| | | KEYSTONE ELECTRONICS CORP. www.keyelco.com • NEW HYDE PARK NY 11040 • Tel (516)328-7500 | | | |
|----------------|------|--|--|----------|---------------|
| | | CERAMIC STANDOFF | | | |
| PER ECN 22-062 | A | TOLERANCES INCH [MM] CODE DWG NO. DECIMAL ± .005 [± 0.13] ANGULAR ± 1° UNLESS OTHERWISE SPECIFIED C DWG NO. 7711 | | DWG NO. | |

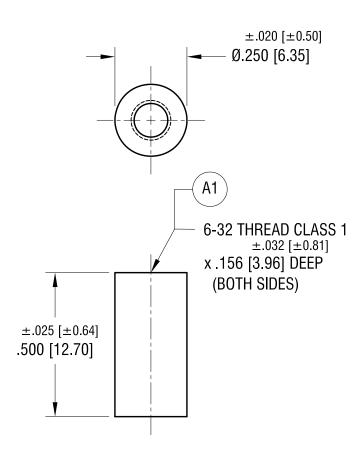
| | | KEYSTONE ELECTRONICS CORP. www.keyelco.com • NEW HYDE PARK NY 11040 • Tel (516)328-7500 | | | |
|----------------|------|--|--|----------|---------------|
| 56 ±.015 DEEP | | | | APP'D RH | SCALE 3X |

A1) WAS $.156 \pm .1$

CHANGE AS PER
